UNITED STATES PATENT AND TRADEMARK OFFICE

10/099,775

Office Action Summary

Annotated figure taken from de Chicchis, Fig. 1

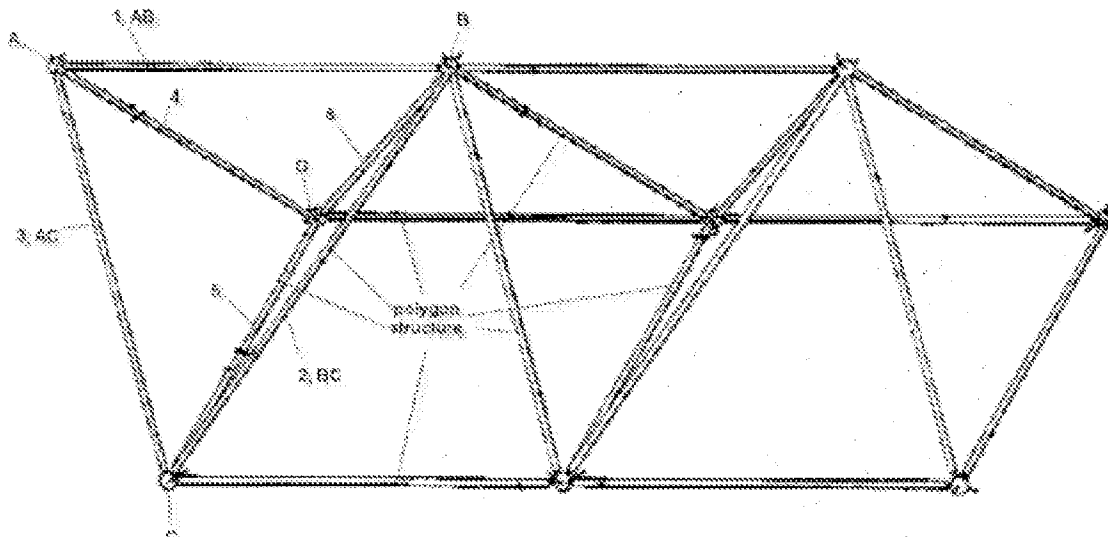
As to claim 1, de Chicchis et al. disclose an architectural system (Fig. 1) comprising a triangular base (1,2, 3, annotated figure) comprising first (1, annotated figure), second (2, annotated figure) and third (3, annotated figure) complete struts substantially aligned along first, second, and third axes (AB, BC, and AC, annotated figure) respectively, the axes all contained within a base plane, the first and third axes forming a first base angle (CAB, annotated figure), the first and second axes forming a second base angle (ABC, annotated figure), the second and third axes forming a third acute base angle (BCA, annotated figure), more than one of the struts each comprising at least two rigid pieces (10, 20, 22, Fig. 2) able to move apart so as to produce a strut elongation; a first node (A, annotated figure) engaging the first and third complete struts, the first node large enough to maintain the first base angle, the first base angle consisting of a first positive value about equal to $(jx20.9^\circ + kx31.7^\circ + mx36^\circ + nx37.4^\circ)$, where j, k, m, and n are each an integer less than three (shown in annotated figure); a second node (B, annotated figure) engaging the first and second complete struts, the second node large enough to maintain the second base angle, the second base angle consisting of a second positive value about equal to $(qx20.9^\circ + rx31.7^\circ + sx36^\circ + tx37.4^\circ)$, where q, r, s, and t are each an integer less than three (shown in annotated figure); a third node (C, annotated figure) engaging the second and third complete struts, the third node C large enough to maintain the third base angle at a third positive value less than 60° (shown in annotated figure); and an extension (4, 5, or 6, annotated figure) engaging the triangular

base and comprising a fourth complete strut substantially aligned along a fourth axis that forms a substantially acute angle $> 3^\circ$ with the base plane (shown in annotated figure). De Chicchis does not teach integers j, k, m, n, q, r, s and t are constrained such that the first, second and third base angles add to 180 degrees. However, it would have been obvious to one of ordinary skill in the art to have the first, second and third base angles add to 180 degrees because in every triangle, the angles always add up to 180 degrees. Therefore, the invention as a whole would have been obvious to one of ordinary skill in the art at the time of the invention.

As to claim 2, de Chicchis et al. disclose the architectural system of claim 1 in which the fourth axis (4, annotated figure) forms an angle DAB with the first axis that is substantially equal to a reference angle selected from a group consisting of $13.3^\circ, 15.5^\circ, 20.9^\circ, 22.2^\circ, 31.7^\circ, 5.3^\circ, 36^\circ, 37.4^\circ, 37.8^\circ, 41.8^\circ, 44.5^\circ, 45^\circ,$

54.7° , 58.3° , 60° , 63.4° , 65.9° , 69.1° , 70.5° , 72° , 75.5° , 76.7° , 79.2° , 82.2° ,
90° , 97.8° , 100.8° , 103.3° , 104.5° , 108° , 109.5° , 110.9° , 114.1° , 116.6° , 120° ,
121.7° , 125.3° , 135° , 135.5° , 138.2° , 142.2° , 142.6° , 144° , 144.7° , 148.3° ,
155.9° , 157.8° , 159.1° , 164.5° , and 166.7° (shown in annotated figure).

As to claim 3, de Chicchis et al. disclose the architectural system of claim 1 in which the fourth axis (5, annotated figure) forms an angle with the second axis that is substantially equal to a reference angle selected from a group consisting of 13.3° , 15.5° , 20.9° , 22.2° , 31.7° , 35.3° , 36° , 37.4° , 37.8° , 41.8° , 44.5° , 45° , 54.7° , 58.3° , 60° , 63.4° , 65.9° , 69.1° , 70.5° , 72° , 75.5° , 76.7° , 79.2° , 82.2° , 90° , 97.8° , 100.8° , 103.3° , 104.5° , 108° , 109.5° , 110.9° , 114.1° , 116.6° , 120° , 121.7° , 125.3° , 135° , 135.5° , 138.2° , 142.2° , 142.6° , 144° , 144.7° , 148.3° , 155.9° , 157.8° , 159.1° , 164.5° , and 166.7° (shown in annotated figure).

As to claim 4, de Chicchis et al. disclose the architectural system of claim 1 in which the fourth axis (6, annotated figure) forms a fourth angle with another of the axes that is substantially equal to a reference angle selected from a group consisting of 13.3° , 15.5° , 20.9° , 22.2° , 31.7° , 35.3° , 36° , 37.4° , 37.8° , 41.8° , 44.5° , 45° , 54.7° , 58.3° , 60° , 63.4° , 65.9° , 69.1° , 70.5° , 72° , 75.5° , 76.7° , 79.2° , 82.2° , 90° , 97.8° , 100.8° , 103.3° , 104.5° , 108° , 109.5° , 110.9° , 114.1° , 116.6° , 120° , 121.7° , 125.3° , 135° , 135.5° , 138.2° , 142.2° , 142.6° , 144° , 144.7° , 148.3° , 155.9° , 157.8° , 159.1° , 164.5° and 166.7° (shown in annotated figure).

As to claim 6, de Chicchis et al. disclose the architectural system of claim 4 further comprising a polygon structure (7, annotated figure) coupled to the fourth complete strut (4, annotated figure), the polygon structure having N sides each occupied by a respective complete strut, the third axis containing one of the N sides, the fourth axis containing another of the N sides wherein the fourth complete strut forms a portion of the polygon structure (shown in annotated figure).

As to claim 7, de Chicchis et al. disclose the architectural system of claim 4 in which $j=0$ (shown in annotated figure).

As to claim 8, de Chicchis et al. disclose the architectural system of claim 4 in which j and q are both even (shown in annotated figure).

As to claim 9, de Chicchis et al. disclose the architectural system of claim 4 in which $j=1$ (shown in annotated figure).

As to claim 14, de Chicchis et al. disclose the architectural system of claim 4 in which $m=0$ (shown in annotated figure).

As to claim 15, de Chicchis et al. disclose the architectural system of claim 1 ~n which $m=0$ (shown in annotated figure).

As to claim 16, de Chicchis et al. disclose the architectural system of claim 1 ~n which j is not equal to q (shown in annotated figure).

As to claim 17, de Chicchis et al. disclose the architectural system of claim 1 ~n which q is less than 2 (shown in annotated figure).

As to claim 18, de Chicchis et al. disclose the architectural system of claim 1 ~n which $k=0$ (shown in annotated figure).

As to claim 19, de Chicchis et al. disclose the architectural system of claim 1 ~n which k and r are both even (shown in annotated figure).

As to claim 20, de Chicchis et al. disclose the architectural system of claim 1 ~n which k is not equal to 1 (shown in annotated figure).

As to claim 21, de Chicchis et al. disclose the architectural system of claim 1 ~n which $n = t$ (shown in annotated figure).

As to claim 22, de Chicchis et al. disclose the architectural system of claim 1 ~n which $j=0$ (shown in annotated figure).

As to claim 23, de Chicchis et al. disclose the architectural system of claim 1 ~n which j and q are both even (shown in annotated figure).

As to claim 24, de Chicchis et al. disclose the architectural system of claim 1 ~n which $j=l$ (shown in annotated figure).
